**DRAFT PLAN OF SUBDIVISION**  
 OF  
 PART OF LOTS 306 AND 307  
 CONCESSION NORTH OF TALBOT ROAD  
 GEOGRAPHIC TOWNSHIP OF SANDWICH SOUTH  
 NOW IN THE  
 CITY OF WINDSOR  
 COUNTY OF ESSEX, ONTARIO  
 © VERHAEGEN LAND SURVEYORS  
 SCALE = 1:500

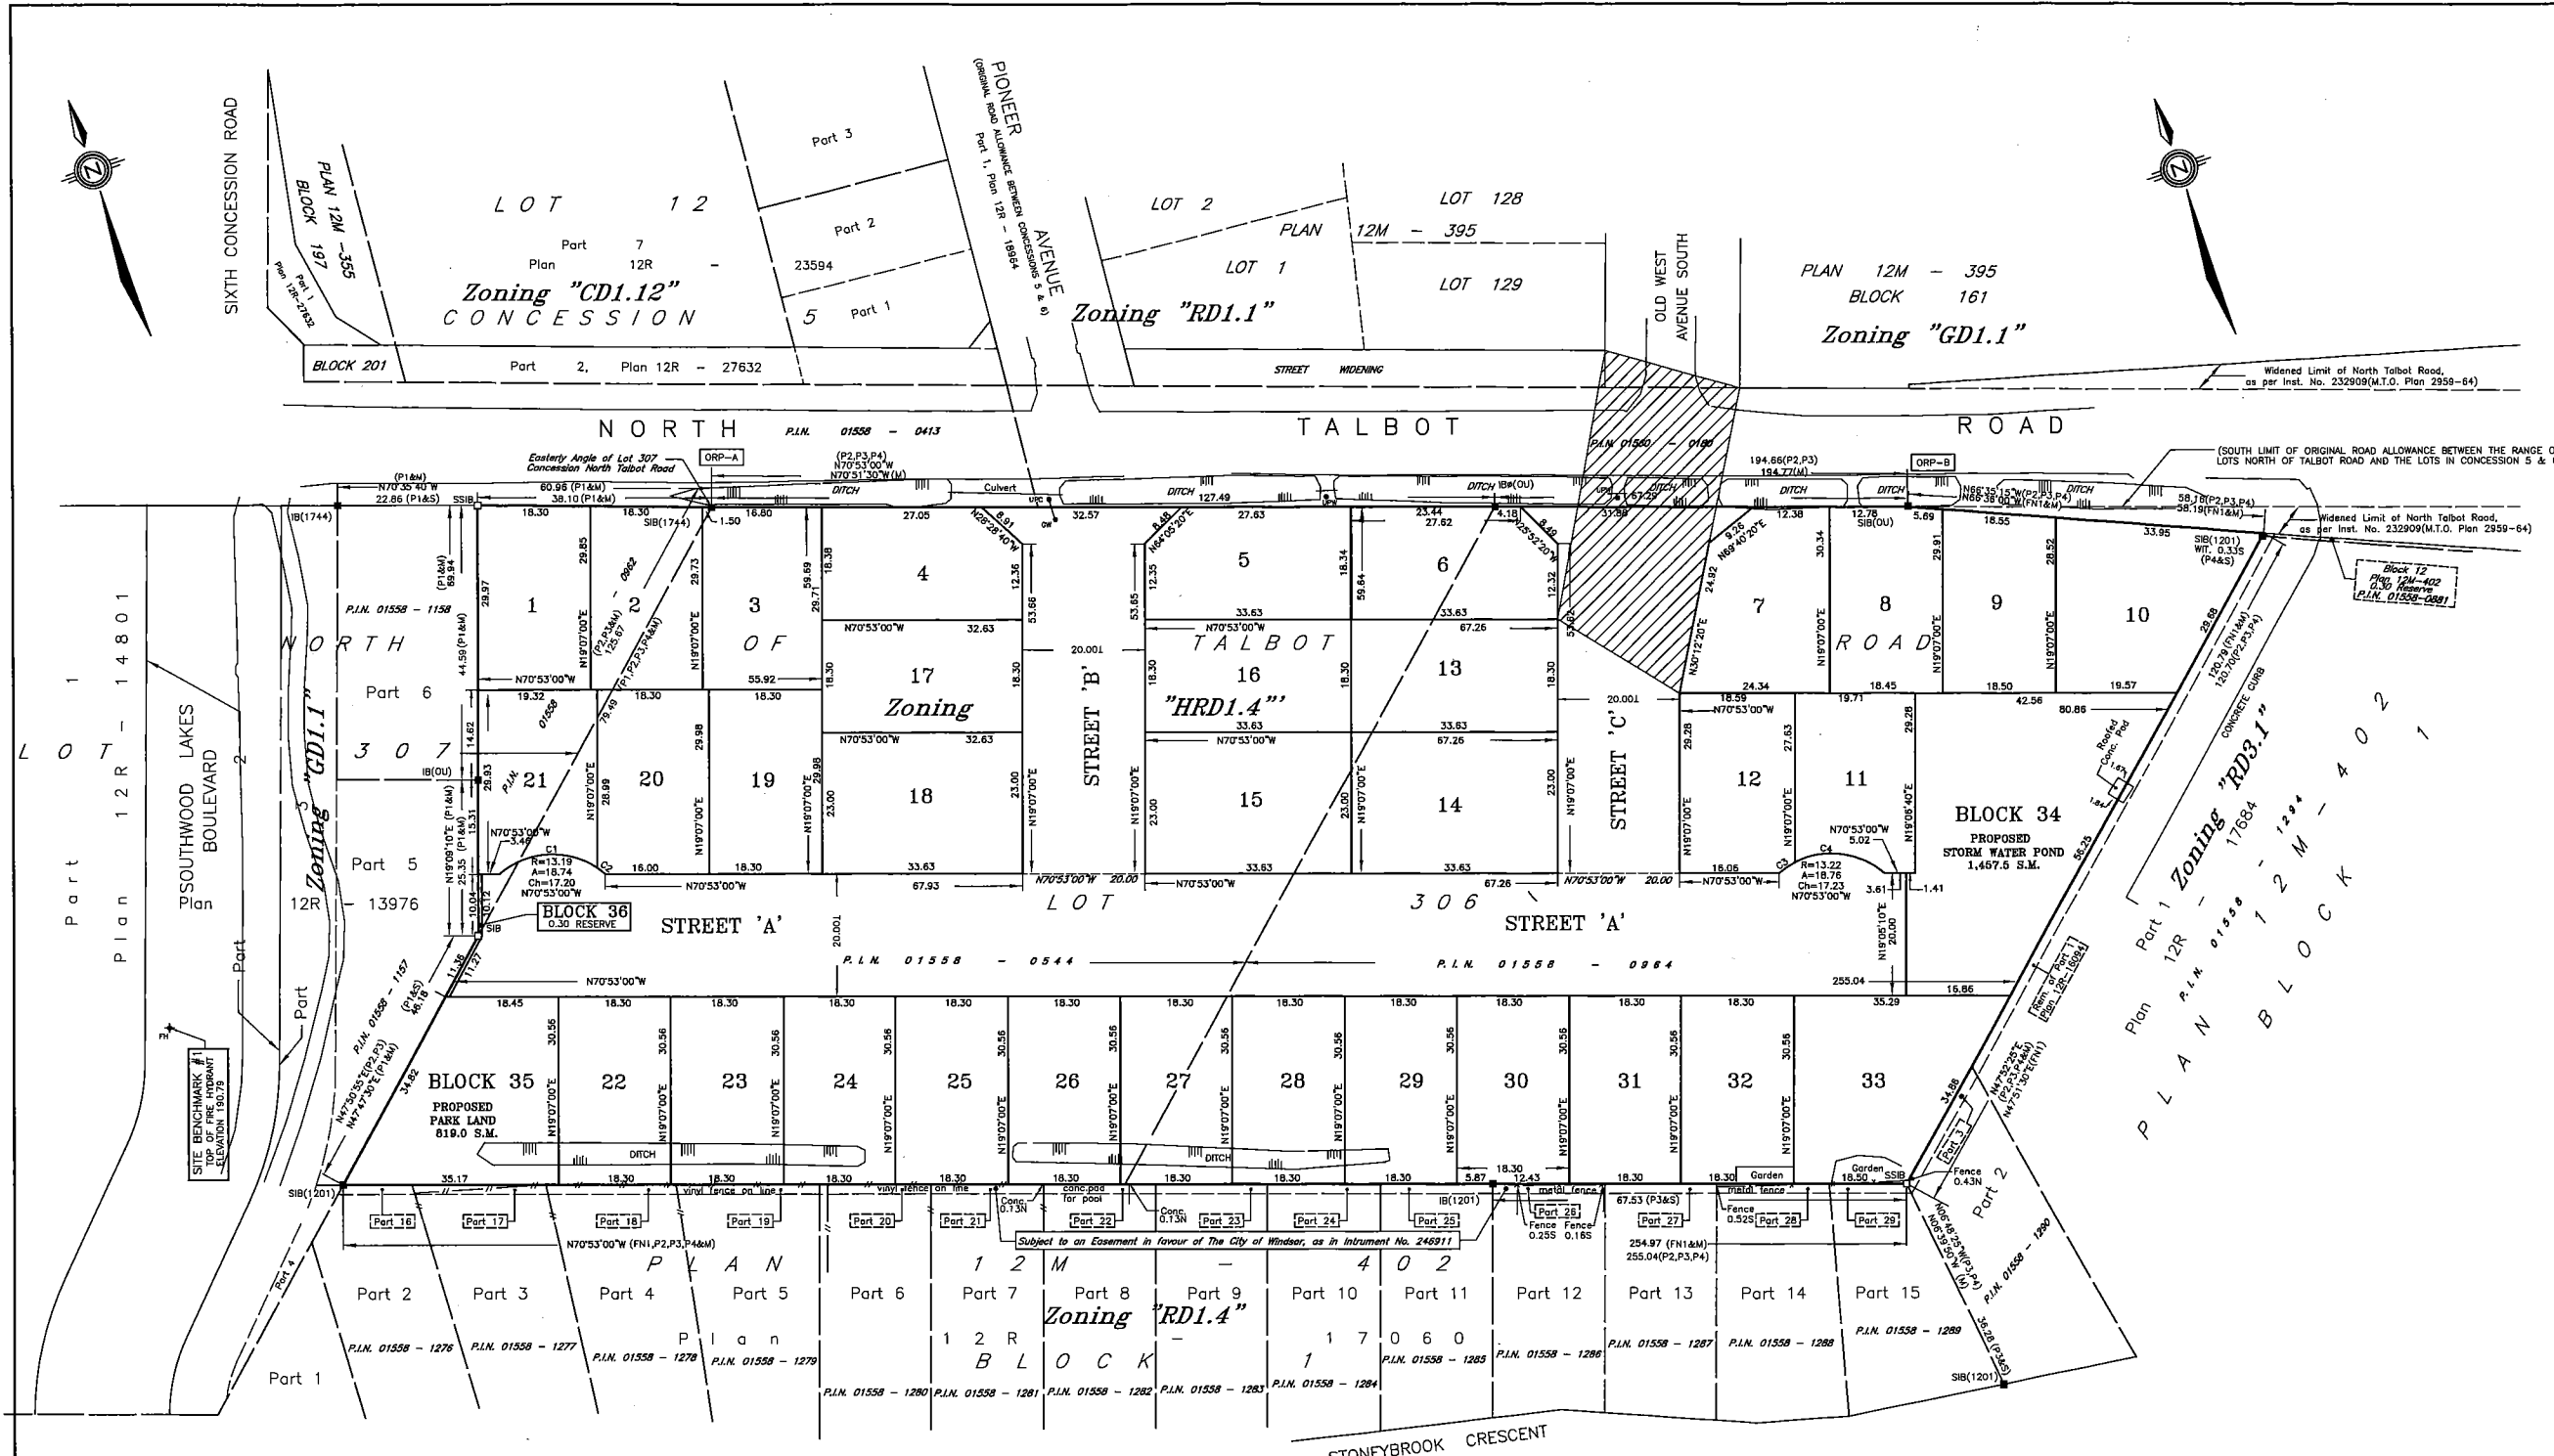
- Corner cut-offs of 4.6 meters are required on North Talbot Road and Streets B and C (lots 4,5, 6 and 7). The submitted plan shows corner cut-offs.
- The new proposed Street B and Street C should align with the intersections to the north of Pioneer Avenue and Old West Avenue South respectively.

**Hydro Engineering:** No Objection, however, a hydro easement may be required to accommodate the existing hydro anchor on the northwest corner of Street B on the draft plan. See attached sketch.

Corner Cut-Off – The owner(s) agrees, prior to the issuance of a construction permit, to gratuitously convey a 4.6m x 4.6m (15' x 15'), corner cut-off at the intersection of North Talbot Road and Street 'B' as well as North Talbot Road and Street 'C' in the Draft Plan, in accordance with City of Windsor Standard Drawing AS-230.

PROJECT TITLE:  
 NORTH TALBOT DEVELOPMENT  
 1095 NORTH TALBOT ROAD, WINDSOR  
 SHEET TITLE:  
 STORM DRAINAGE AREA PLAN

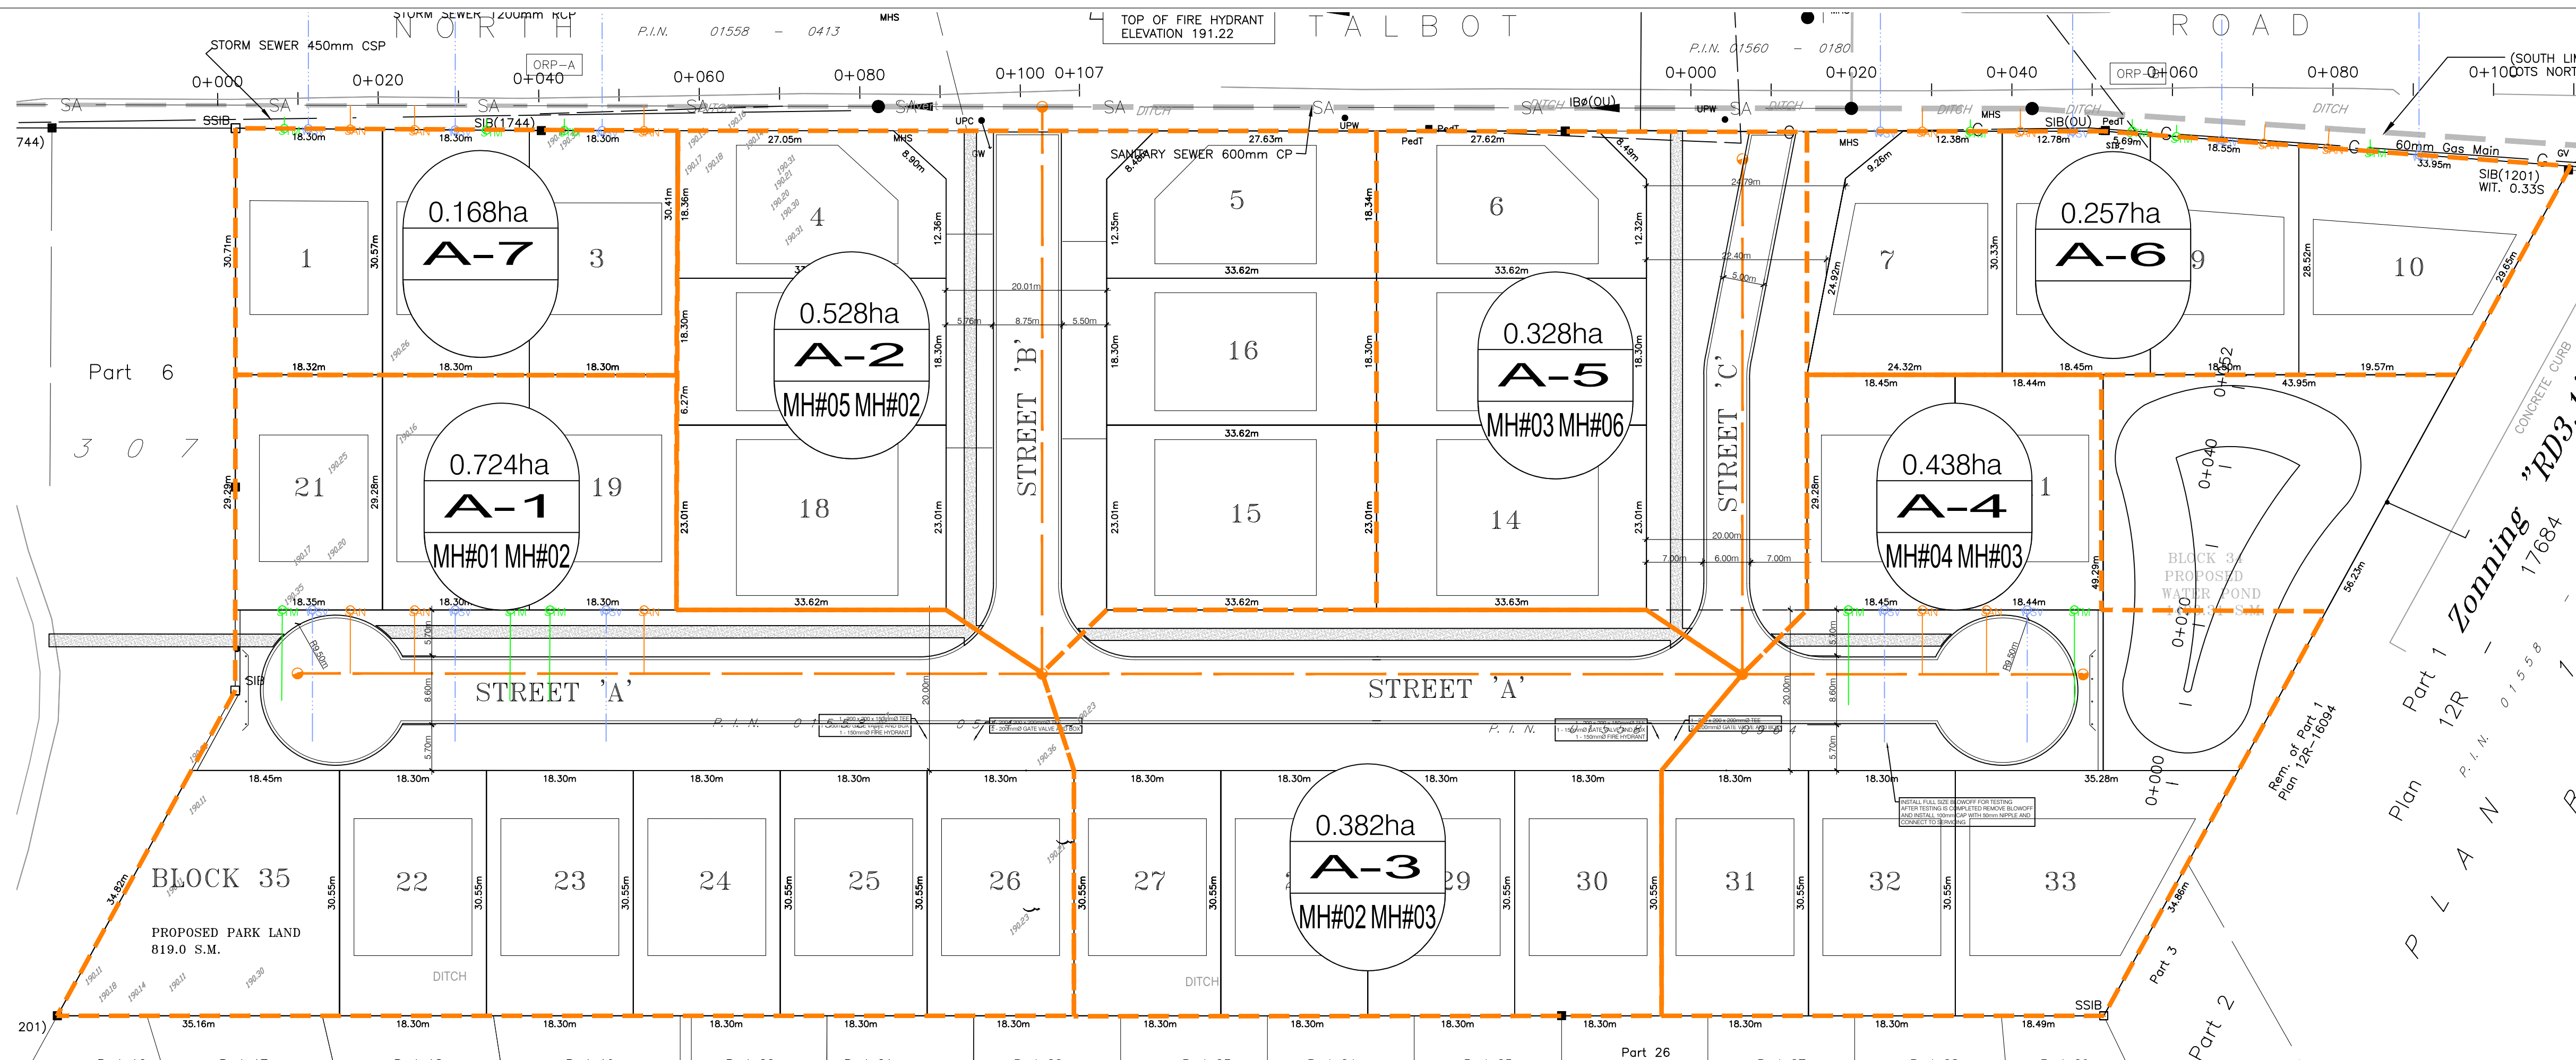
- Is an easement required behind blocks 7, 9, 9, 35 for the 250 mm storm sewer. If this is the case, please provide confirmation that the easement is satisfactory to the City.

- Sewer design sheet is missing A-7, Tc is selected as 10 mins but inlet time shows 20 mins. Please clarify.
- What is the purpose of the ditches on the North and South end of the property? Are these for storage or conveyance? Where is the water directed to?
